Subject: Proposed Fill in Headwaters or Isolated Wetlands  
Wake Stone Corporation - Triangle Quarry Expansion  
Wake County

RE: Renewal/Modification of Cary Quarry  
Mining Permit No. 92-10  
Wake County

This office has completed its initial review of your request to renew and modify the above referenced mining permit. The items in need of further clarification are as follows:

LONGITUDINAL SECTION  
THROUGH TST-4

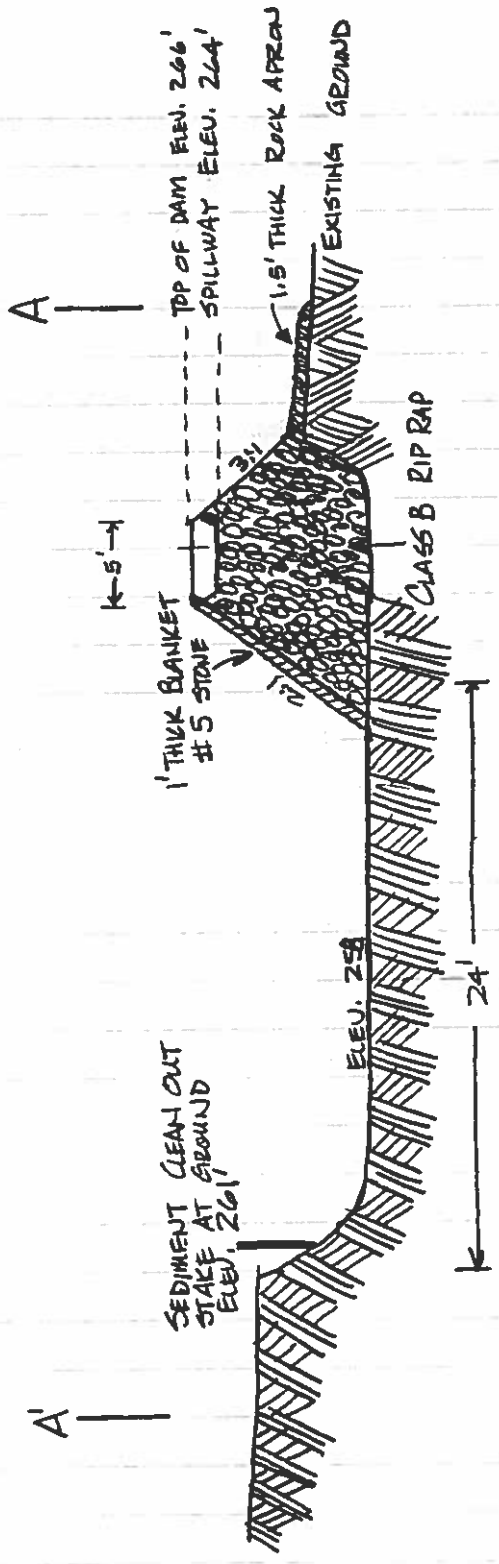
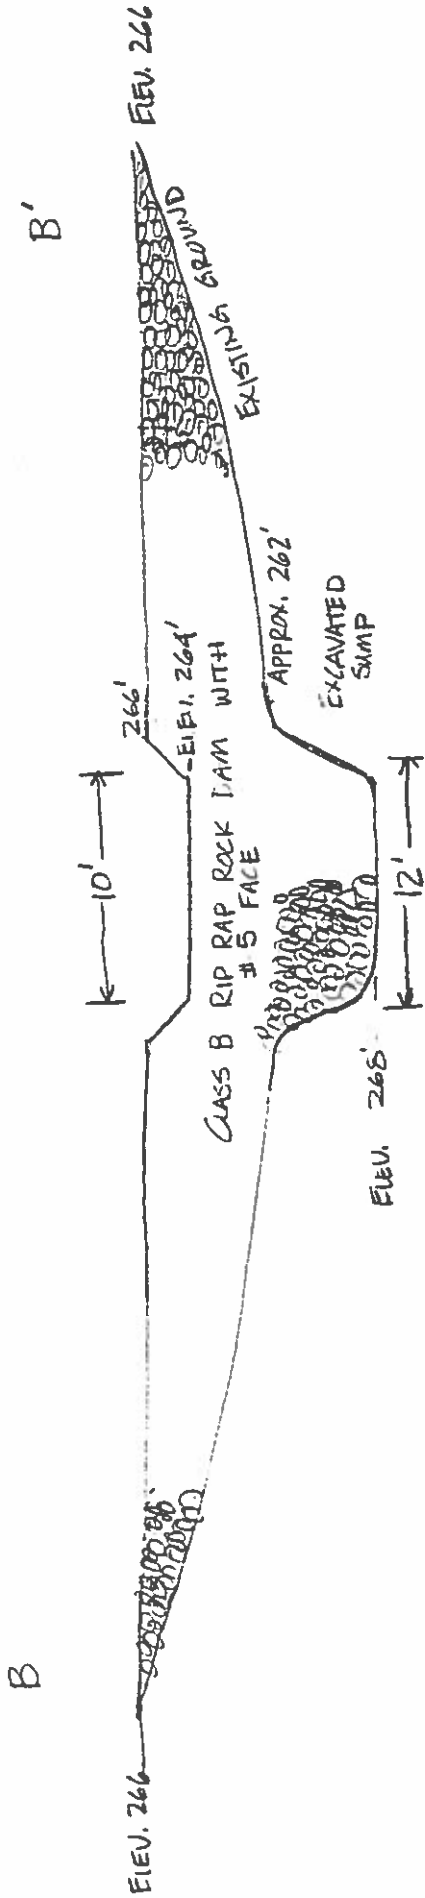
- (1) "TST-4" has not been properly designed. It must be redesigned to accommodate the runoff from the drainage area leading to sediment basin "C." Therefore, a properly designed rock dam must be provided as a minimum.
- (2) Although the TSTs and "Permanent" Sediment Basins are too deep to provide for efficient settling using the 1800 cubic feet per acre design criteria, many of the surface areas specified in your calculations appear reasonable if a 900 cubic feet per acre design criteria is used and said structures are cleaned out when they become 1/2 full of sediment. Therefore, the dimensions for TST-3, TST-4, TST-5, Sediment Basin "A" and Sediment Basin "B" are acceptable in light of the limited use planned for these structures.

SEDIMENT POOL  
SUMP DIMENSIONS  
24' x 12' x 6' = 1,728 FT<sup>3</sup>

LONGITUDINAL SECTION THROUGH  
BASIN C

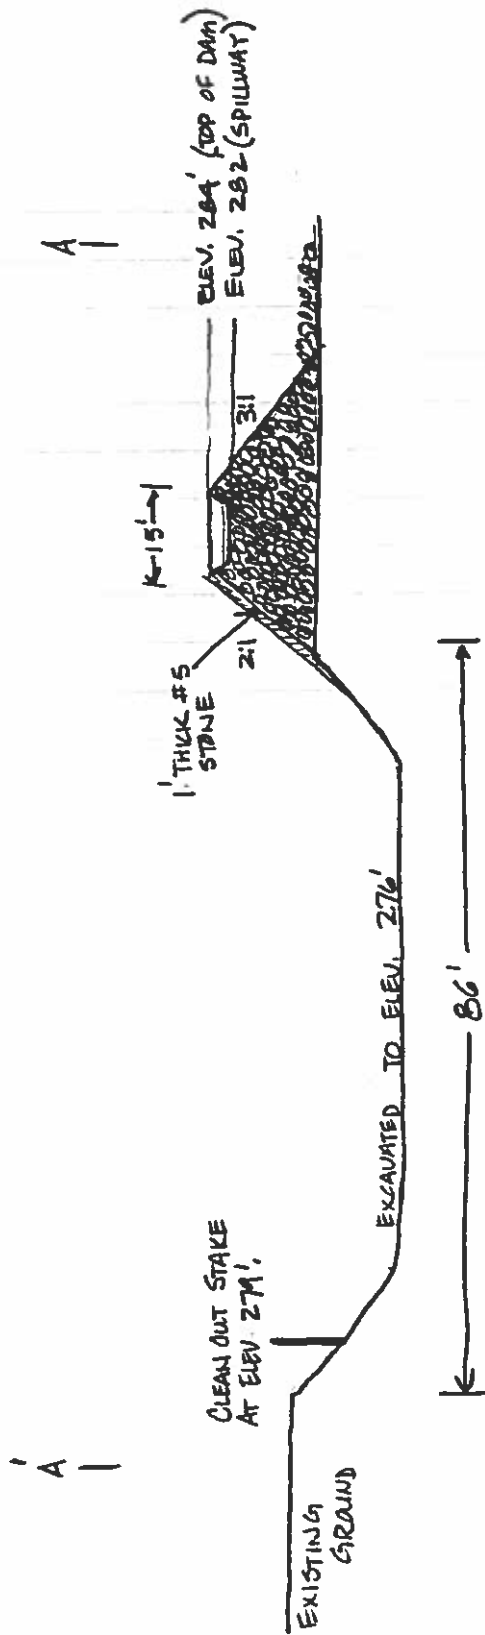
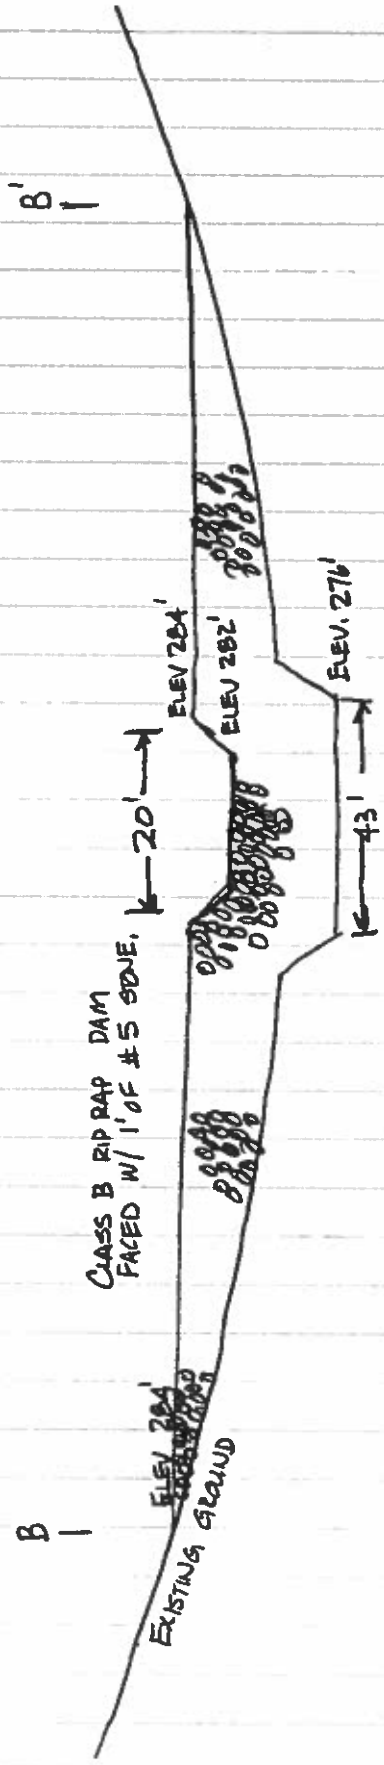
- (4) The construction details for the Temporary Sediment Traps and "Permanent" Sediment Basins are not fully consistent with the design specifications and it appears that an arched stone filter was intended for Sediment Basin "C." It is strongly recommended that the construction details be upgraded to denote the items specified on the details provided in the Erosion and Sediment Control Planning and Design Manual.

RE-DESIGN BASIN C TO INCREASE SETTLING EFFICIENCY. KEEP SEDIMENT ZONE DEPTH TO 3 FEET.

$$1800 \text{ FT}^3/\text{AC} \times 12.4 \text{ AC DRAINAGE AREA} = 22,320 \text{ FT}^3$$
